SECTION 15. FIGURES for the Report – Defective Groundwater Protection Practices at the Sandia National Laboratories’ Mixed Waste Landfill – The Sandia MWL dump - Version December 30, 2010

Figure 11A. Water table contour map that shows the southwest direction of the local groundwater flow at the water table below the Sandia MWL dump in April 2000 . The well network is inadequate to determine the actual direction of groundwater flow to the south or southwest.

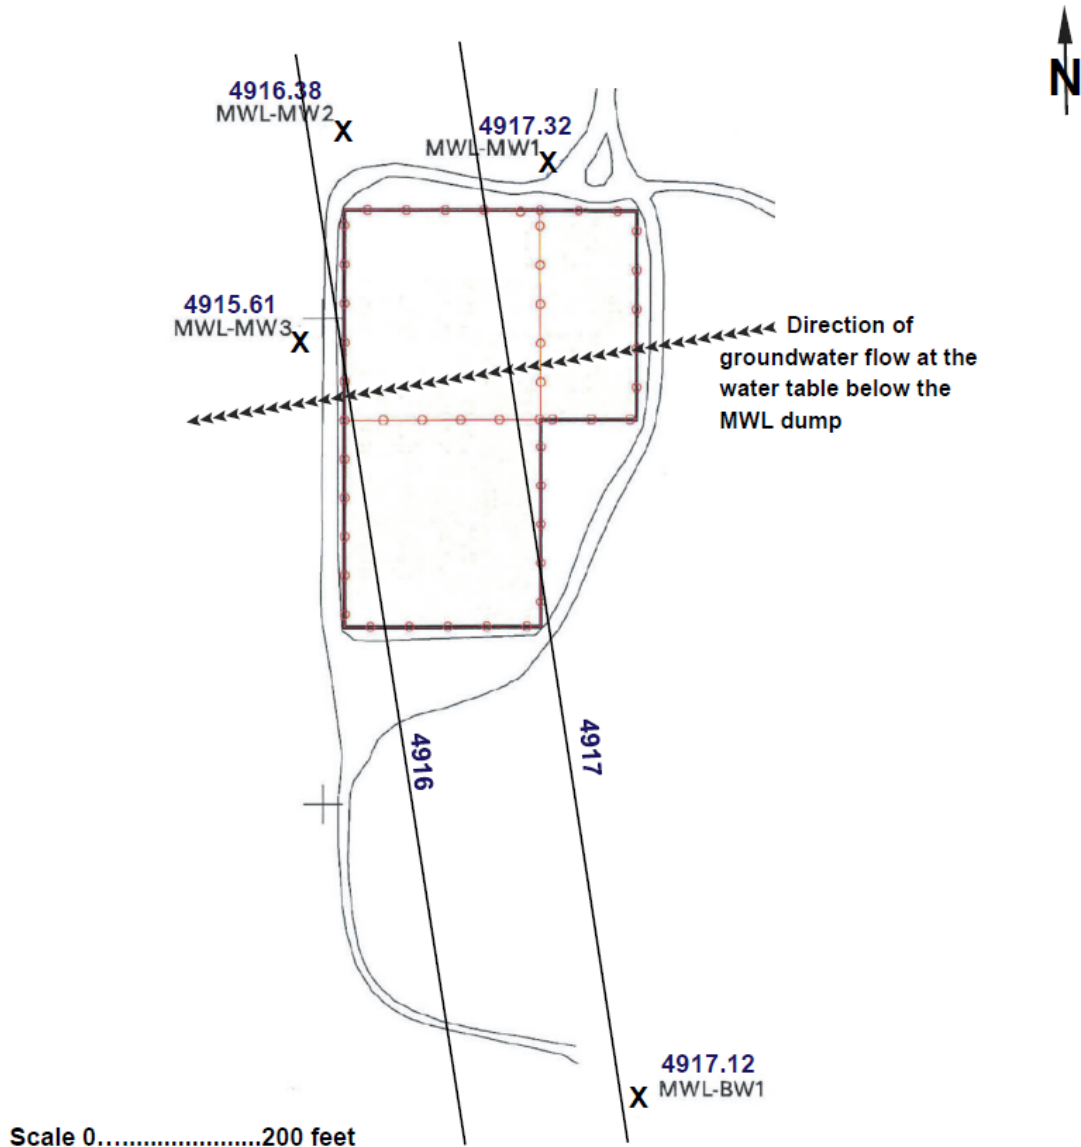
NOTE: The local contour map on this figure shows the southwest direction of groundwater flow at the water table below the Sandia MWL dump. The contour map is constructed using the water table elevations posted on Figure 11. Figure 11 shows that the regional direction of groundwater flow is to the northwest. But the local flow direction below the MWL dump is to the southwest and the local flow direction is important for the selection of the locations of monitoring wells.

Figure 12A. Enlarged view of Figure 12 to show the water table elevations posted on Figure 12 for the three monitoring wells MWL-MW1, -MW2 and -MW3 at the Sandia MWL dump.

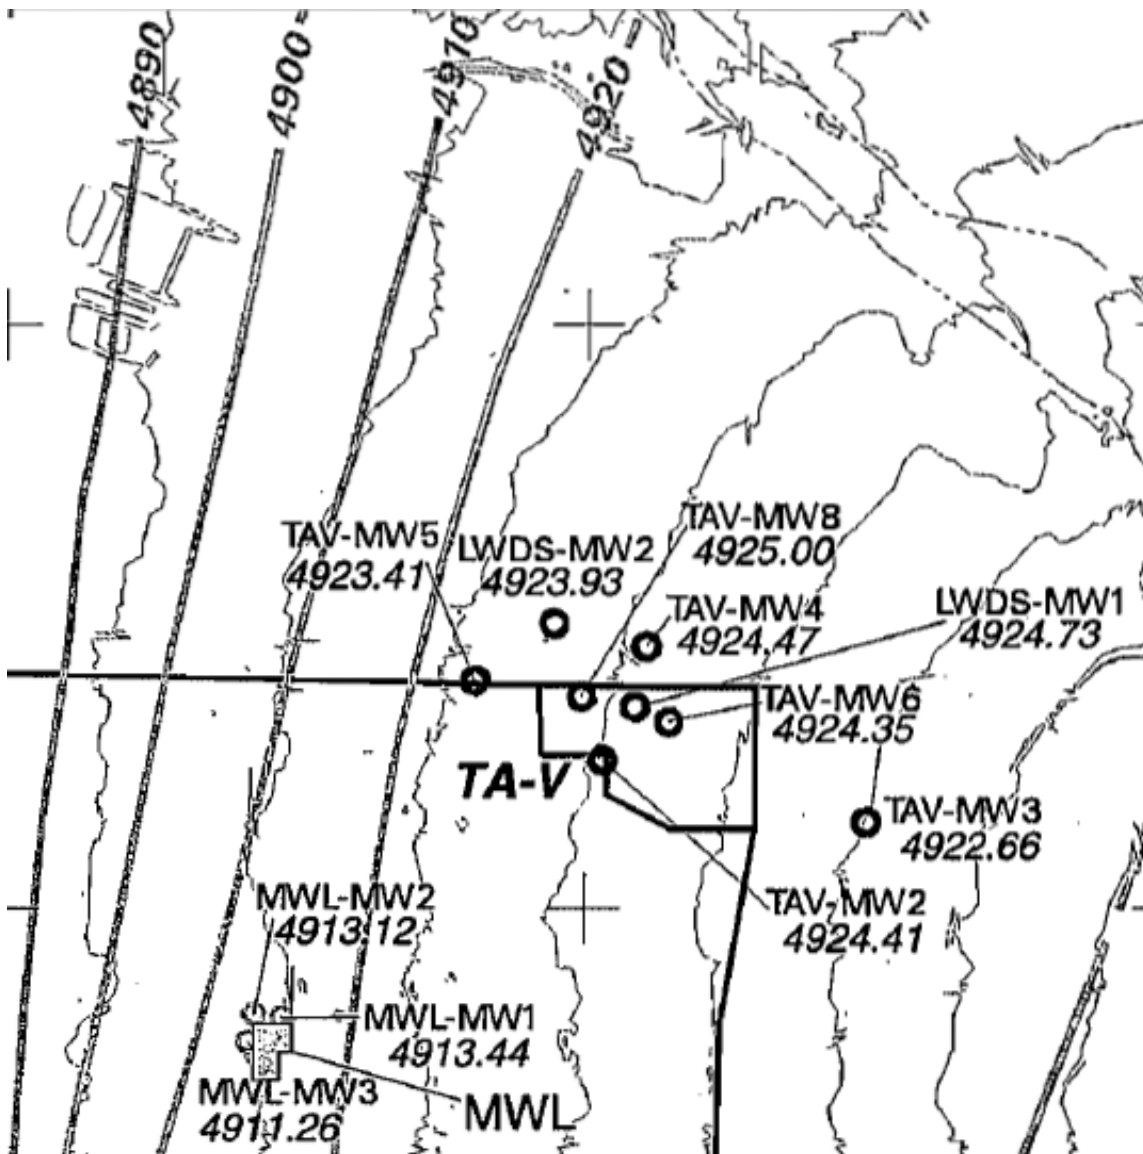
NOTE: The water table elevations measured in the three wells MWL-MW1, -MW2 and -MW3 indicate the direction of local groundwater flow at the water table in the fine-grained alluvial fan sediments below the MWL dump is to the south or southwest and not to the northwest as displayed by the contour lines on the regional flow map in Figure 12

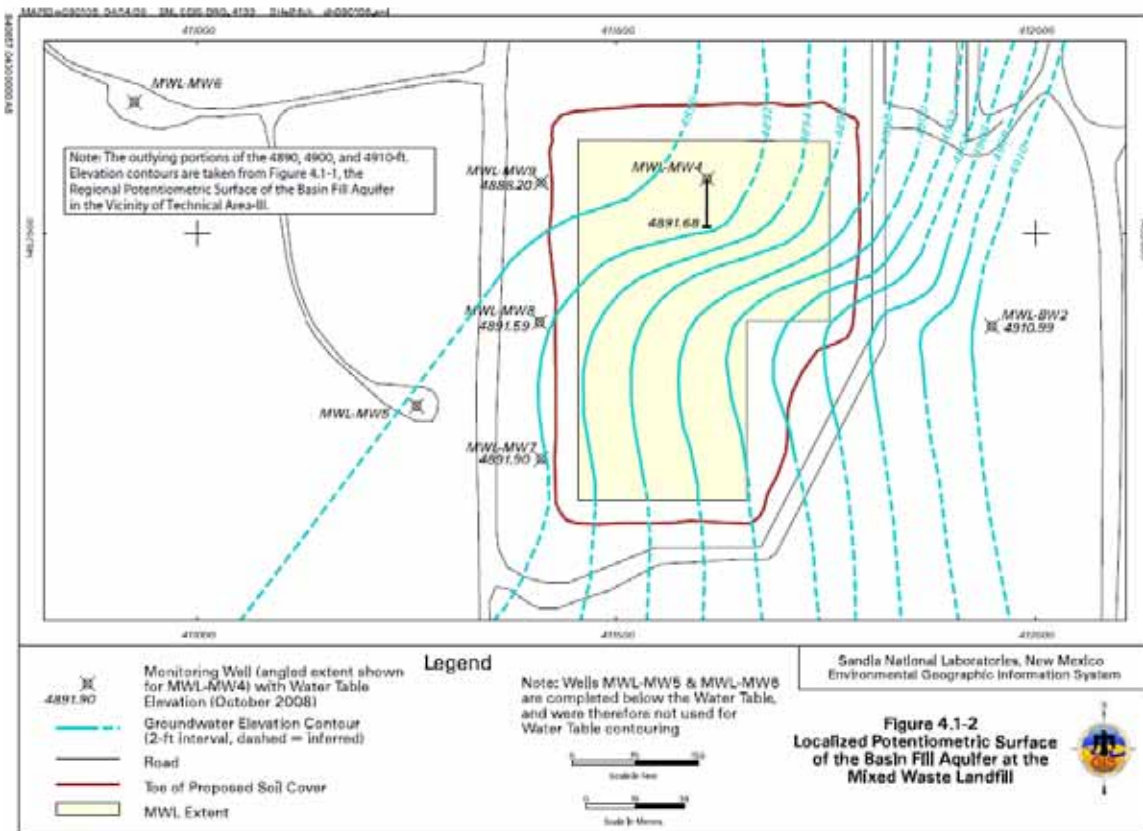
NOTE: The water level contours on this map are not accurate for the direction or lateral gradient of groundwater travel at the water table in the fine-grained alluvial sediments below the Sandia MWL dump. The best water table contour map for the MWL dump is Figure 14 below.

Figure 13A. Enlarged view of water level contour map in Figure 13 for water levels measured in October 2008.

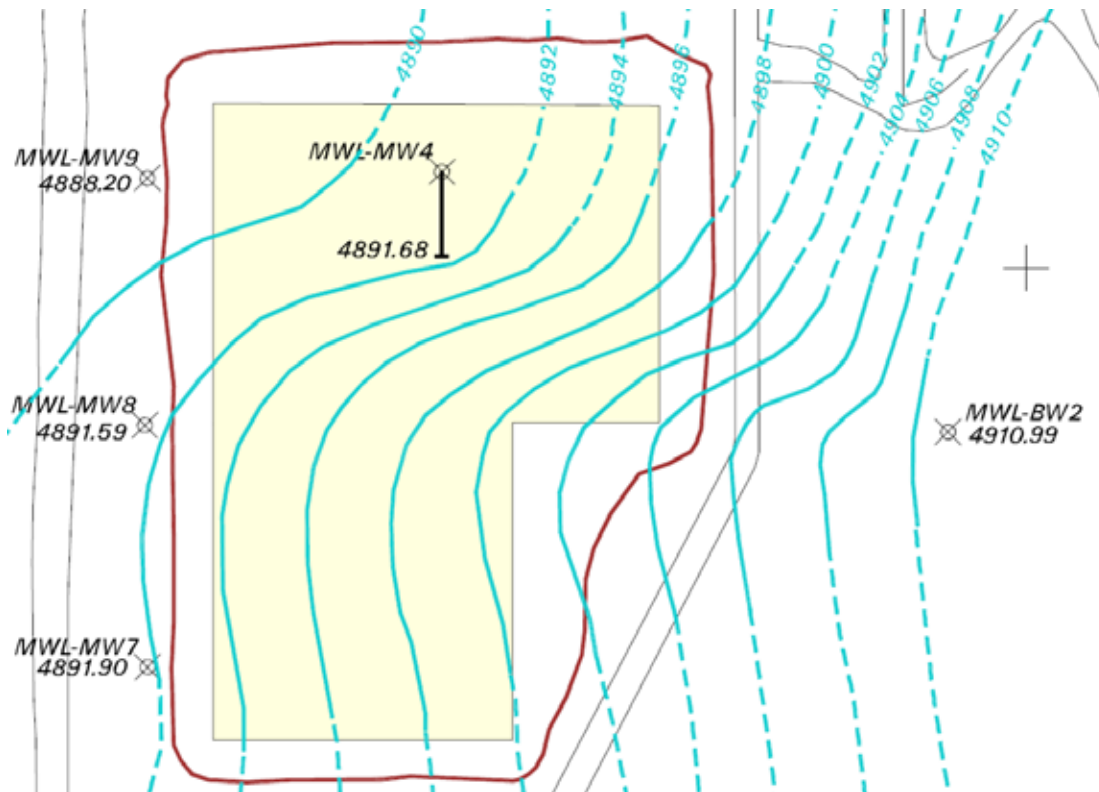
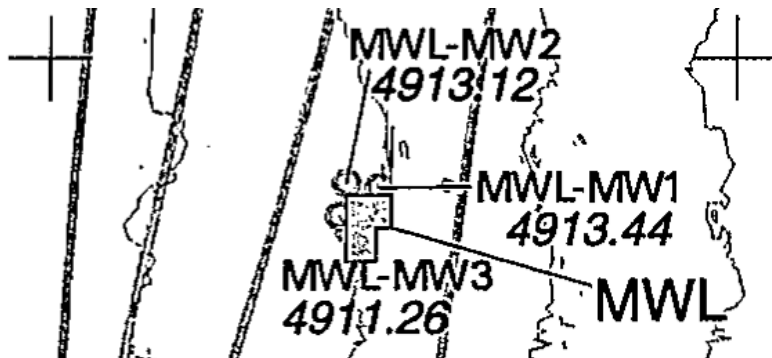
Note: Figure 8 shows that well MWL-MW3 was located along the western side of the MWL dump midway between the new monitoring wells MWL-MW8 and -MW9. The ~20 ft lower measured elevation of the water table along the western side of the Sandia MWL dump in the new monitoring wells MWL-MW7, -MW8 and -MW9 is unreasonable compared to the water table elevation measured in well MWL-MW3. The error in the water levels in the new wells is because of the mistakes that were made in the drilling method, drilling operations and well design (i.e., 30-ft screen length).

Figure 18. Total nickel concentrations measured in groundwater samples collected from monitoring wells MWL-MW1, -MW2, MW3, MW4 and -BW1 at the Sandia Mixed Waste Landfill.

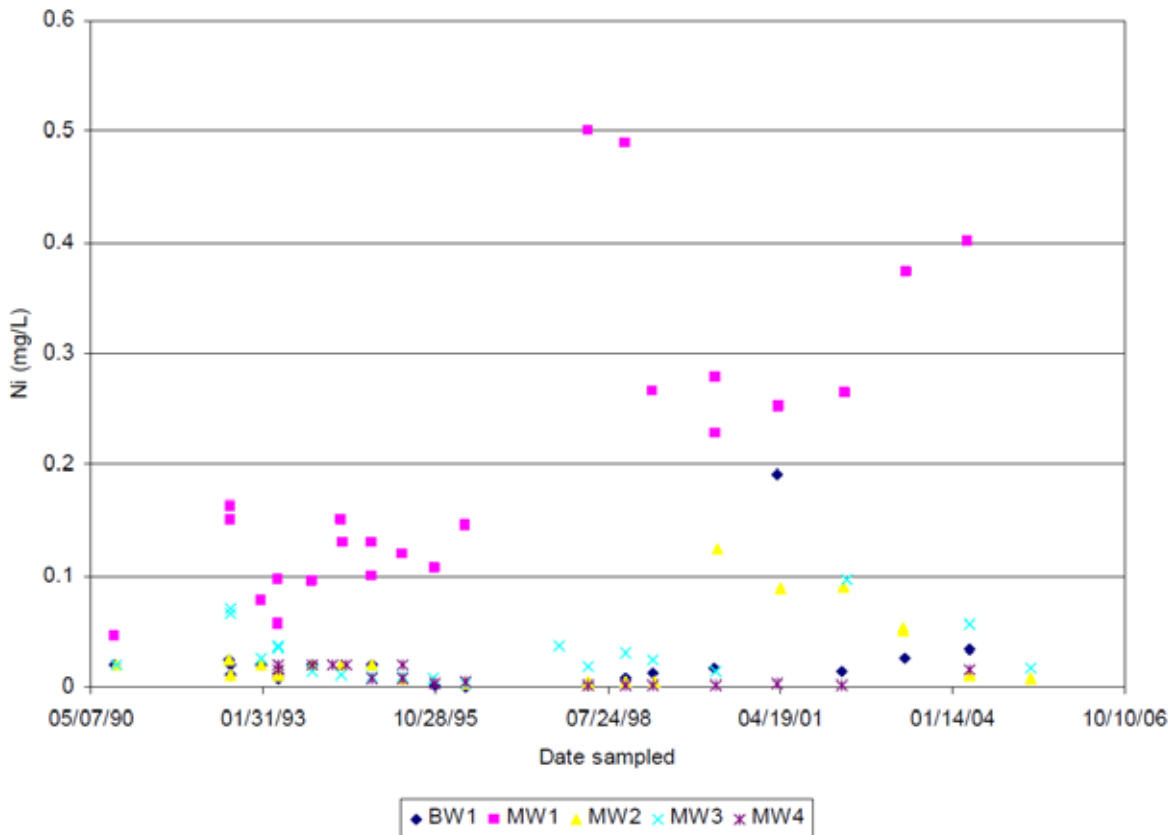
Note: Monitoring wells MWL-MW1, MW2 MW4 and BW1 have corroded stainless steel screens. The screen in monitoring well MWL-MW4 is the plastic PVC.

Note: The US Environmental Protection Agency recommends the nickel concentration in drinking water to not exceed 0.1 milligrams per liter (100 parts per billion). All of the nickel concentrations measured in water samples collected from well MWL-MW1 after 1993 are greater than 0.1 mg/L with many concentrations ranging above 0.2 mg/L to near 0.5 mg/L (500 parts per billion).

Note: The high nickel concentrations measured in the water samples collected from well MWL-MW1 are evidence of nickel contamination from the Sandia MWL dump.

Figure 19. Comparison of 1995 and 2008 Tritium sediment sample analytical results for the 10-, 30- and 50-foot depth samples at the Sandia MWL dump.

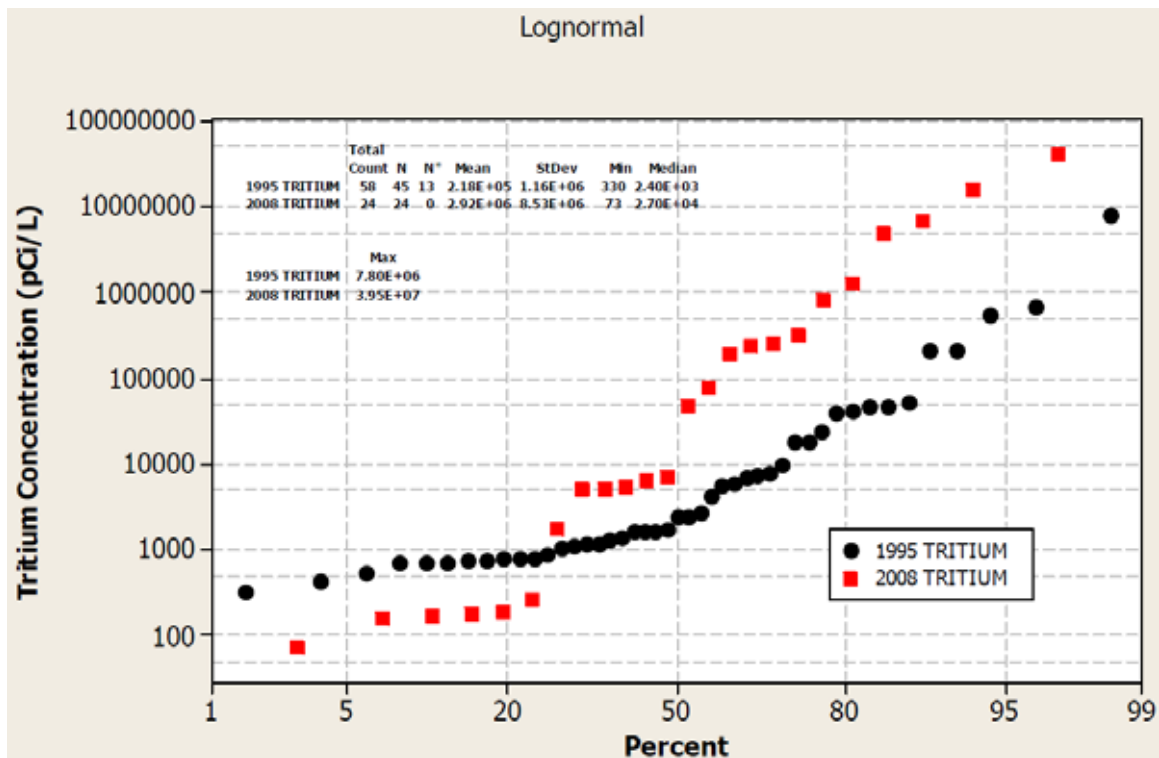
Note: The half-life of tritium is 12.3 years. Therefore, the maximum tritium concentration measured in the 2008 soil samples was expected to be 50% less than the maximum value measured 13 years earlier in 1995. The maximum value expected to be measured in the 2008 study was approximately 3,900,000 pCi/L.

However, the maximum tritium concentration measured in 2008 was 39,500,000 pCi/L and ten times greater than the expected maximum concentration. The high tritium concentrations measured in the 2008 samples is evidence of a new release of contamination from the wastes buried in the MWL dump.

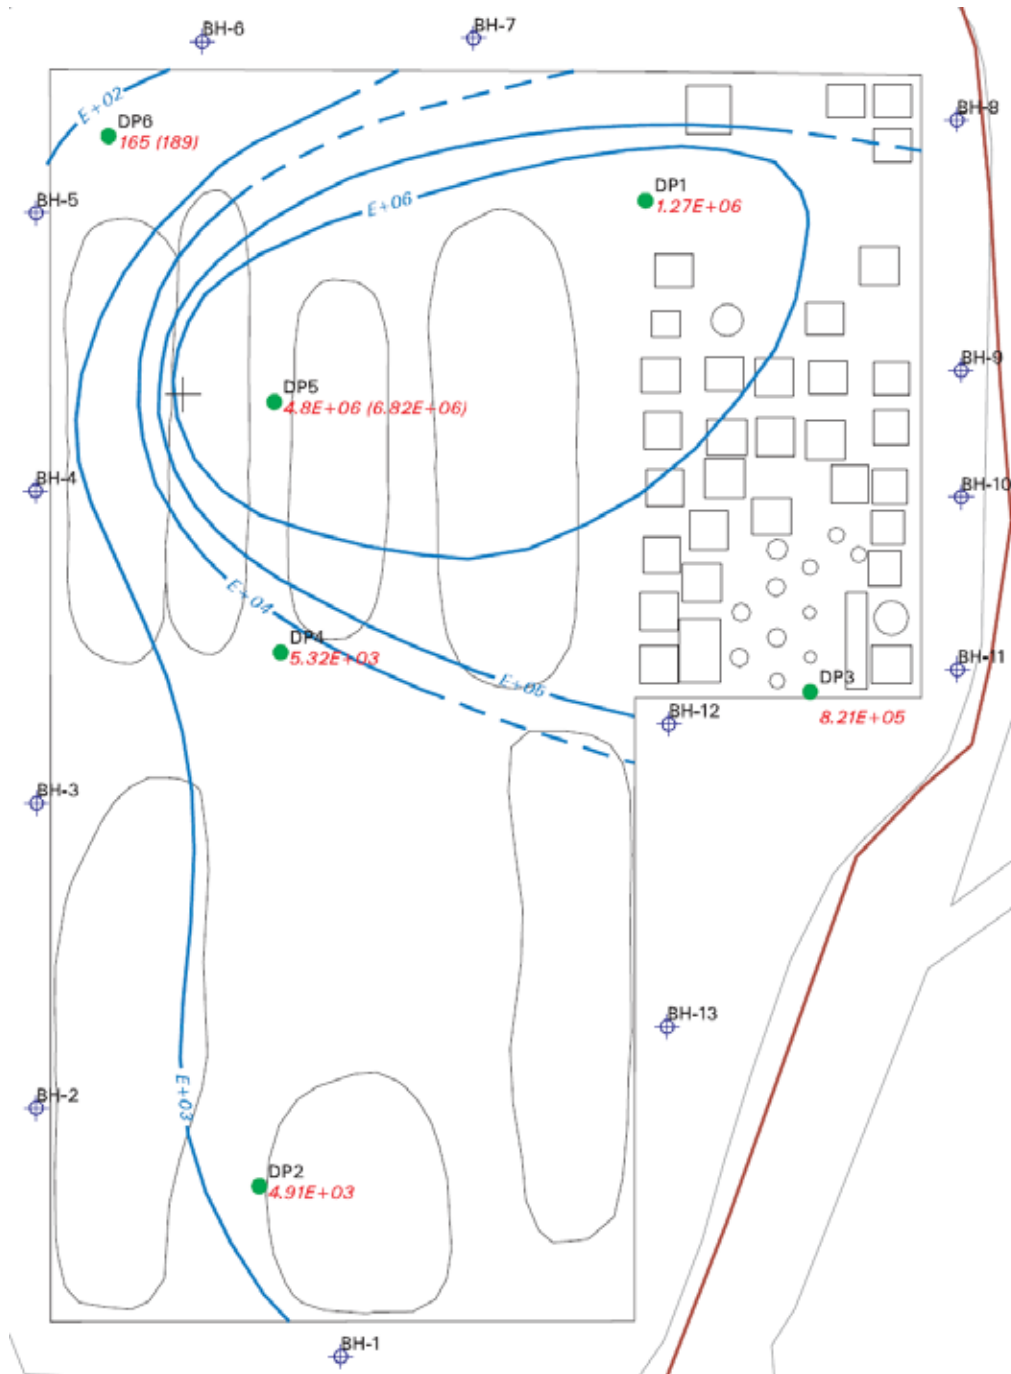
Figure 24A. Enlarged view of Figure 24 to show the locations of the 6 30-foot depth sample locations reading down the page for sample locations DP6, DP1, DP5, DP4, DP3 and DP2. None of the 6 sample locations were located near the pits or trenches where the large inventory of tritium wastes were known to be buried.

Figure 25. Unreliable isopleth map of the Tritium contamination at the 50-foot depth below the Sandia MWL Dump for only 3 sample locations.

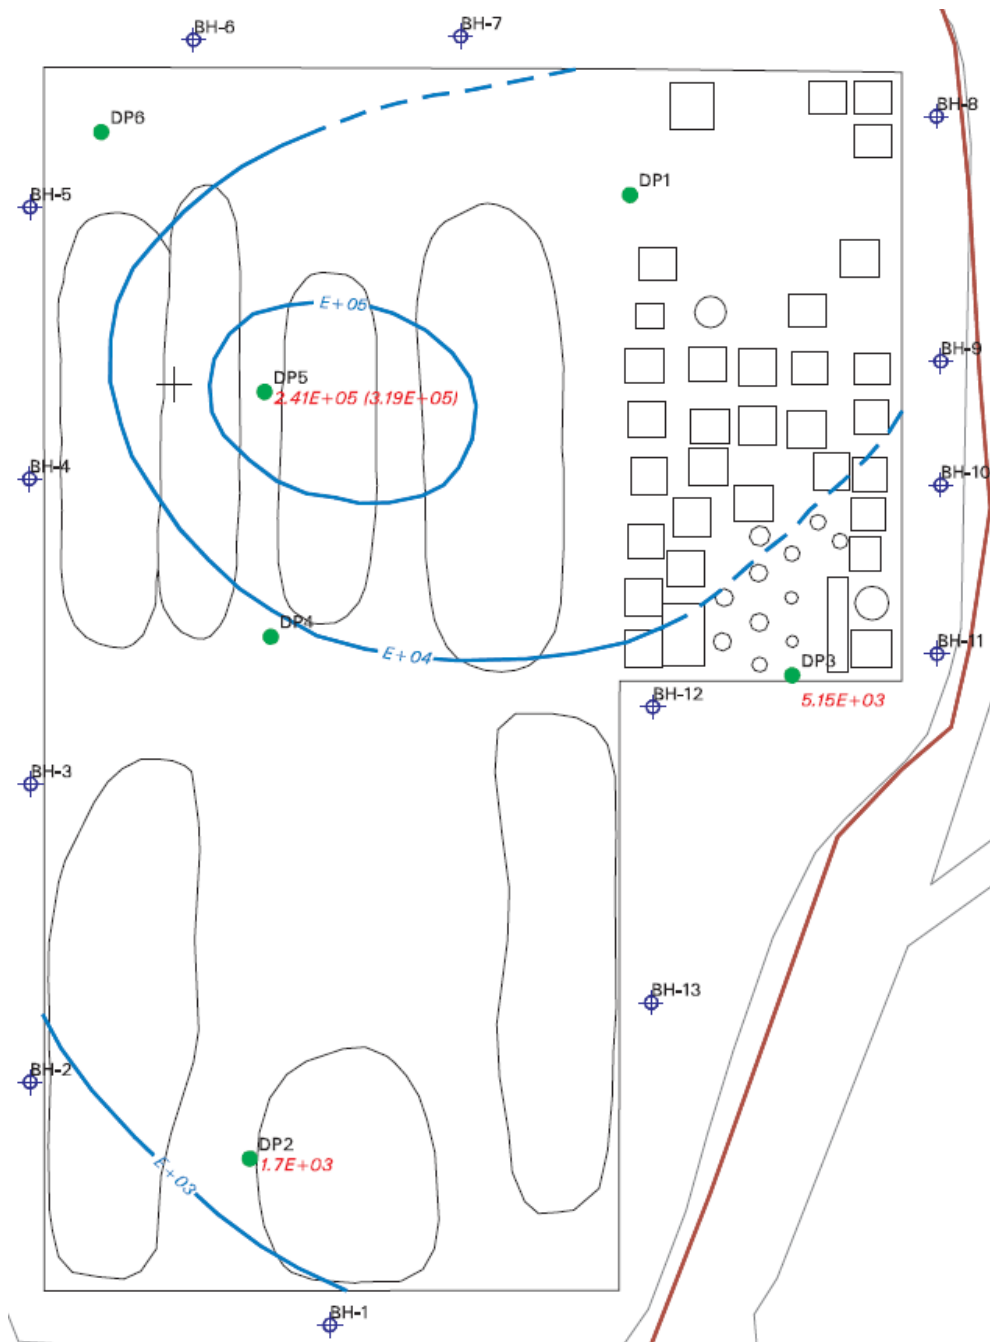
NOTE: The three sample locations from bottom to top of map are DP2, DP3 and DP5. None of the three sample locations are near the trenches and pits where the large inventory of tritium wastes were known to be buried.

Figure 29. The predicted concentrations of PCE contamination in the groundwater below the Sandia MWL dump derived from 100 simulations with the DOE/Sandia computer fate and transport model.

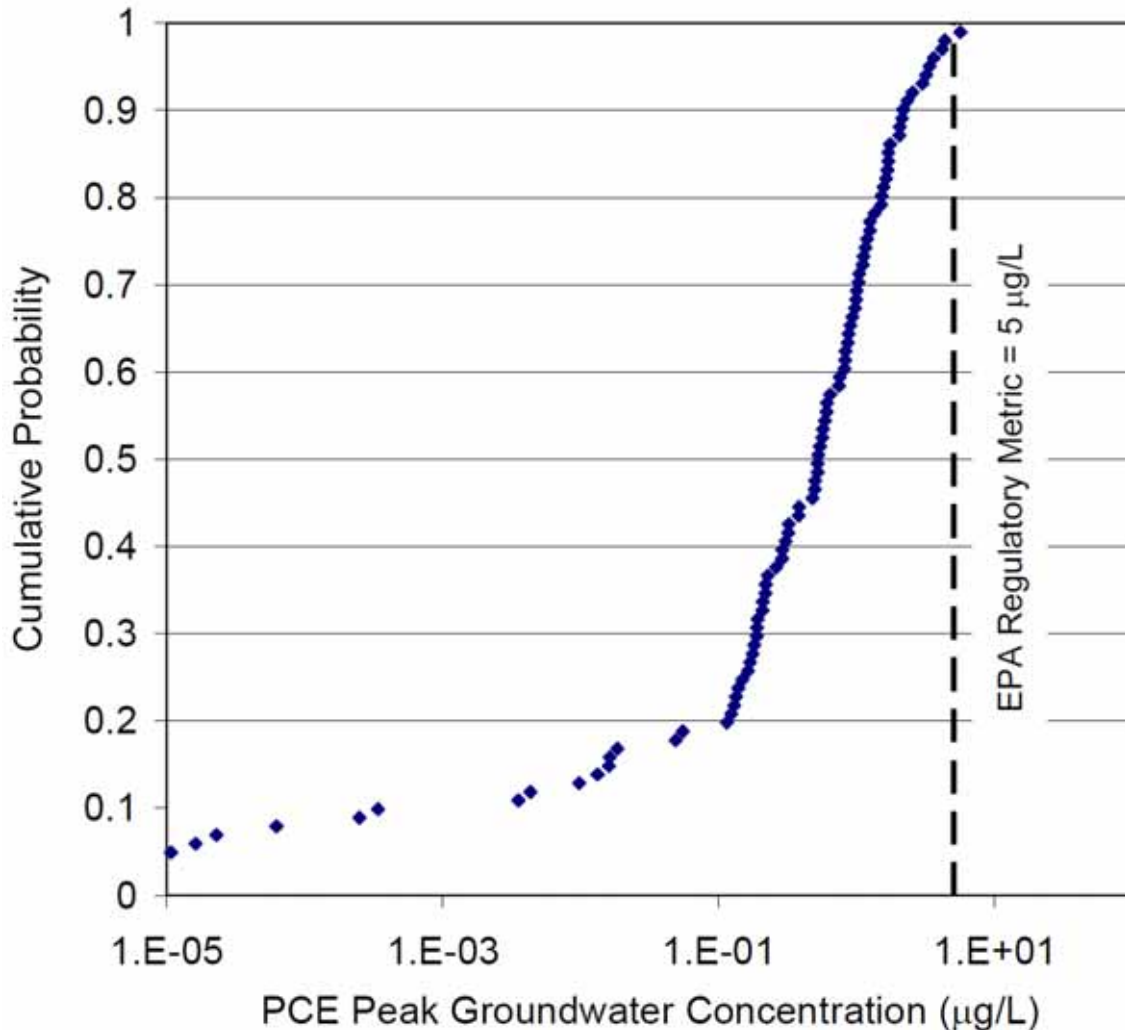
The EPA will promulgate a new drinking water standard (DWS) maximum contaminant level (MCL) for PCE in 2011. The EPA has indicated the new DWS MCL will be set at 0.05 ug/L, a 100-fold tightening from the current MCL of 5 ug/L.

- The above figure shows that 87 of the 100 DOE/Sandia computer simulations predict that the groundwater below the MWL dump is contaminated with PCE at a concentration above 0.05 ug/L.
- The above figure shows that 59 of the 100 DOE/Sandia computer simulations predict that the groundwater below the MWL dump is contaminated with PCE at a concentration above 0.5 ug/L.
